# Access Compliance Report

## Public Rights-of-Way

### (Curb Ramps)

Intersection ID: 18778	Main Street: E_INDEPENDENCE_BV	Cross Street: E_W_T_HARRIS_BV	Location: NE
ADA ID: 05AC7B0CDB6C	Ramp Type: PerpDiag	Initial Pass/Fail: Fail	Overall Compliance: No
Severity Score: 13.75			
Codes/Mitigation Info/Possible Solution		Field Measurements/Component Compliance

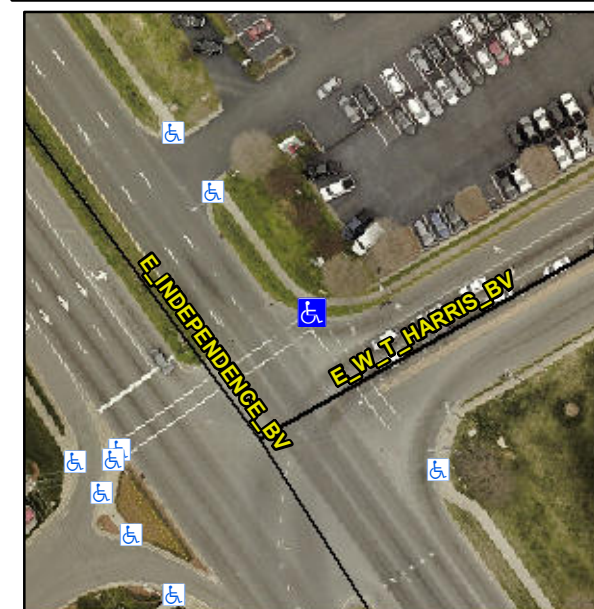
**Not Found, R304.2.2, R304.5.3**

Compliance	Description	Data	Compliance	Description	Data
N/A	Ramp Length (in)	59.0	No	Ramp Slope (%)	8.9
Yes	Ramp Width (in)	48.0	No	Ramp XSlope (%)	4.2
N/A	Flare Type LT	N/A	N/A	Flare Type RT	N/A
N/A	Flare Slope LT (%)	N/A	N/A	Flare Slope RT (%)	N/A
N/A	Flare Traversable LT?	N/A	N/A	Flare Traversable RT?	N/A
N/A	Landing Length (in)	N/A	N/A	DWS Provided?	N/A
N/A	Landing Width (in)	N/A	N/A	DWS Contrast?	N/A
N/A	Landing Slope (%)	N/A	N/A	DWS Length (in)	N/A
N/A	Landing X Slope (%)	N/A	N/A	DWS Full Width?	N/A
N/A	Landing Curb? (Y/N)	N/A	N/A	DWS Offset (in)	N/A
N/A	Shared Landing?	N/A			
N/A	Gutter Ponding?	N/A	N/A	Gutter Slope (%)	N/A
N/A	Gutter Lip Ht (in)	N/A	N/A	Gutter X Slope (%)	N/A
N/A	Painted X Walk1?	Yes	N/A	Painted X Walk2?	Yes
	X Walk 1 Direction	To W		X Walk 2 Direction	To S
N/A	X Walk 1 Width (in)	86.0	N/A	X Walk 2 Width (in)	85.0
	X Walk 1 Slope (%)	2.9		X Walk 2 Slope (%)	3.7
	X Walk 1 X Slope (%)	2.2		X Walk 2 X Slope (%)	2.1

**Remove & Replace Curb Ramp With Two New Directional Ramps or Equivalent.**
